SOFTWARE RELEASE NOTES

Product: Bad Boy® Spot Luminaire

Subject: Software Version 1.8

Bulletin No: BAD-011

INFORMATION SCREEN

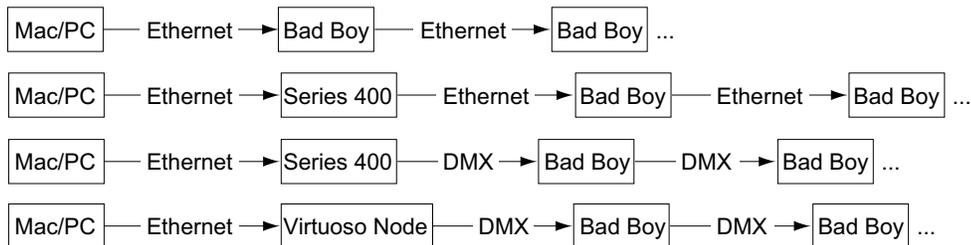
- + Main menu screen now displays the software version.
- + Info menu screen now displays the boot version.

Software Version

Boot Version
